Parks and Wildlife

Addendum No. 1 - 8/5/24 Rifle Falls SFU – Isolation Building

FINAL WITH ADDENDUM NO. 1
PROPOSED SITE PLAN

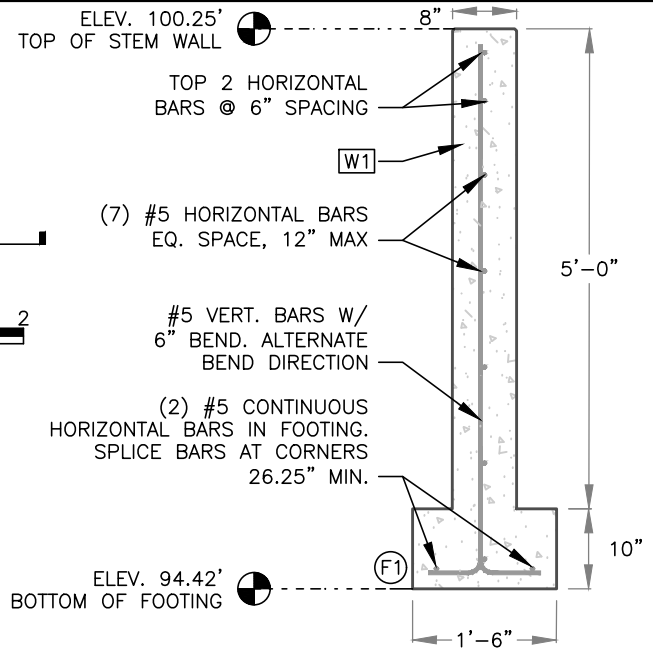
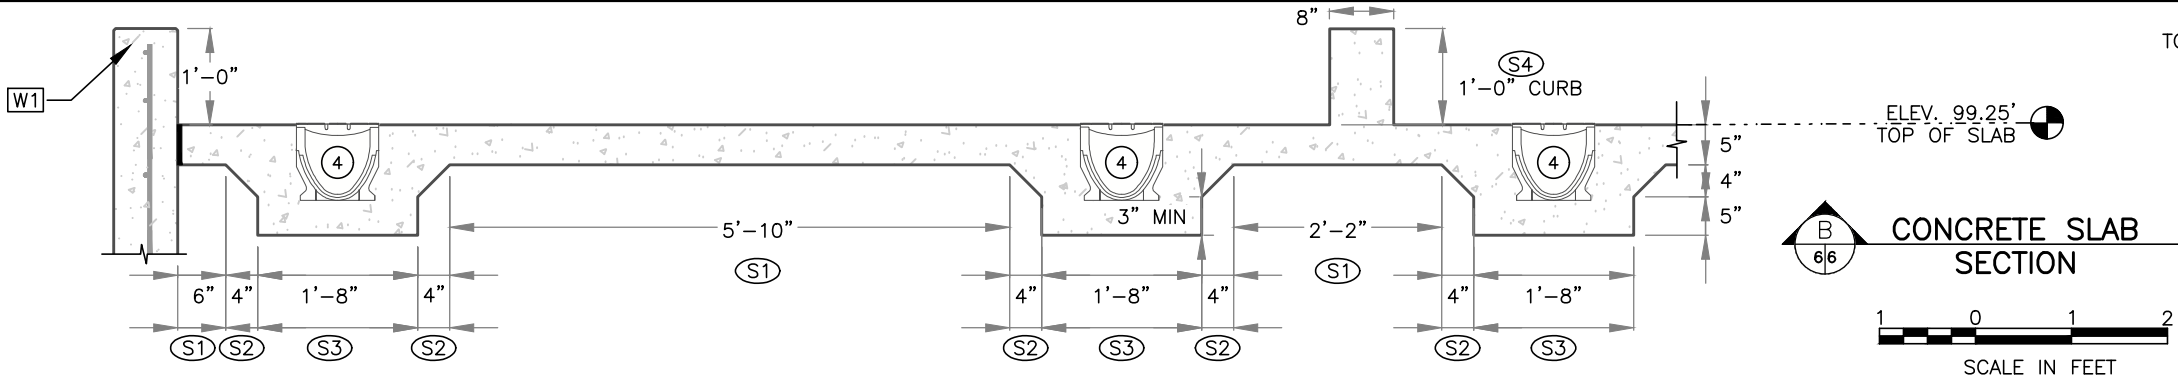
SHEET 3 - PROPOSED SITE PLAN

REMOVE:

EXISTING 16" PVC REX SUPPLY LINE

ADD:

EXISTING 15" SCH 80 PVC REX SUPPLY LINE

FINAL FOR BID
FOUNDATION PLAN

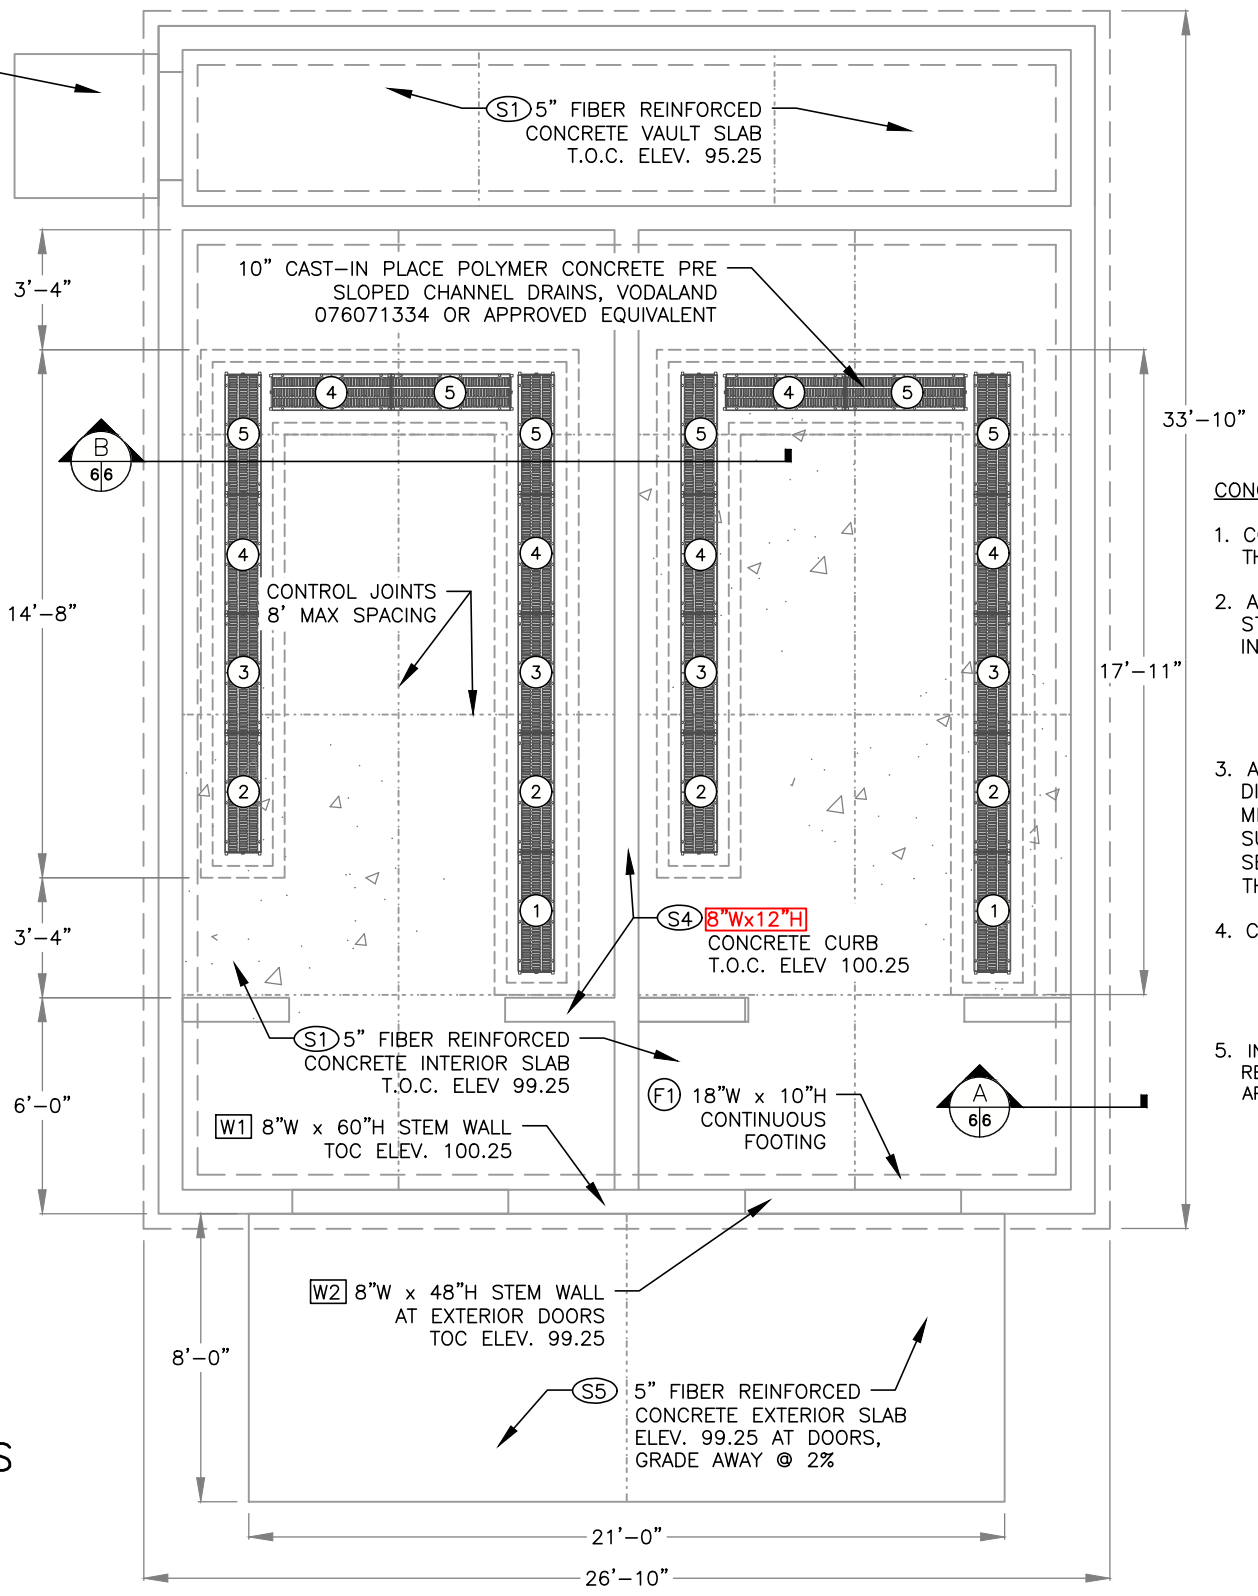
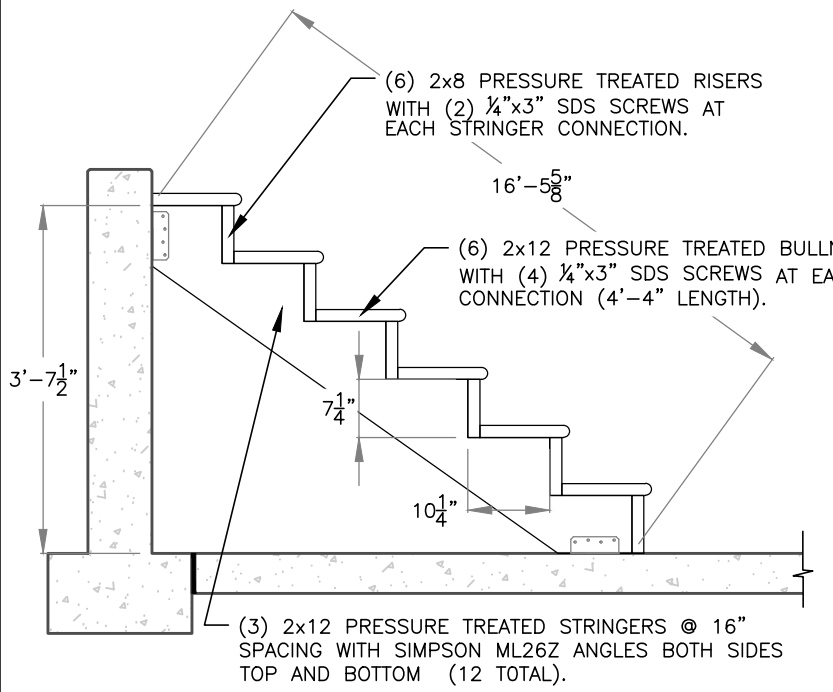
SHEET 6 - FOUNDATION PLAN

REMOVE:

S4 - 8" Wx10" H CONCRETE CURB

ADD:

S4 - 8" Wx12" H CONCRETE CURB

FINAL FOR BID
FRAMING PLAN

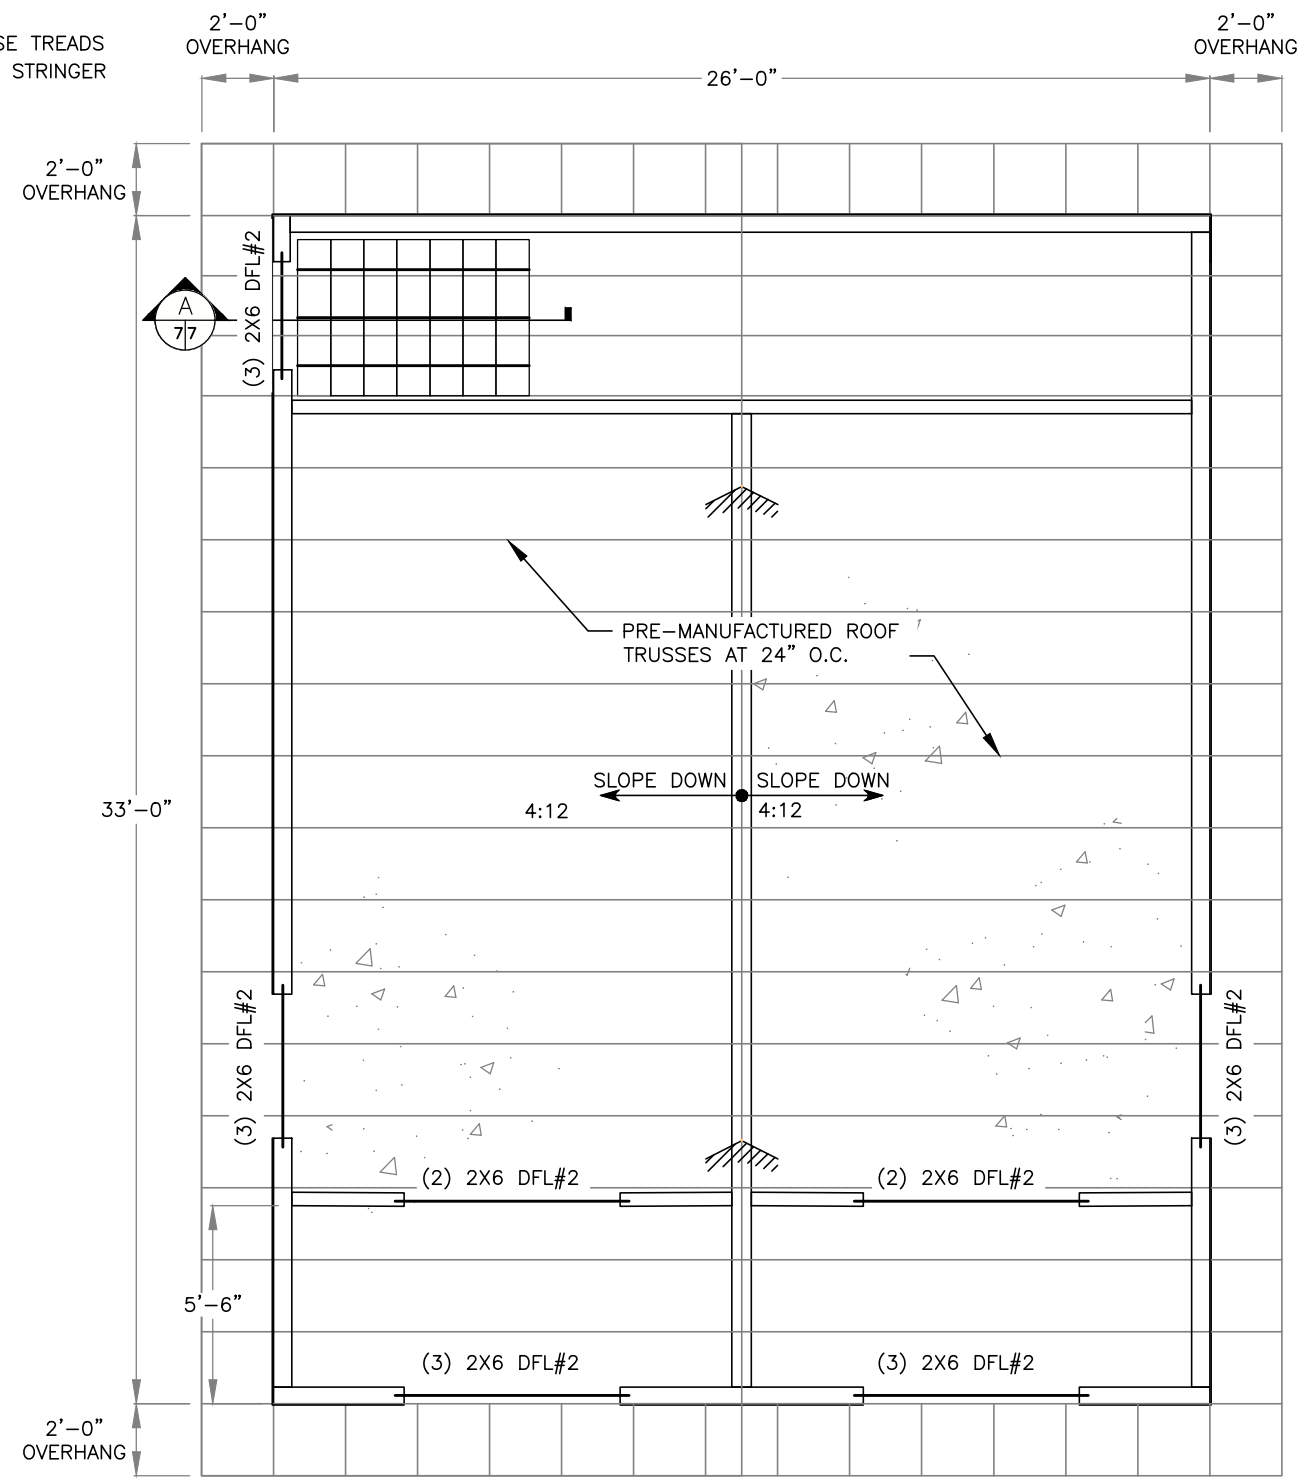
SHEET 7 - FRAMING PLAN

ADD:

STAIN STEPS ACCORDING TO SECTION 09900.

STAIN STEPS ACCORDING TO SECTION 09900.
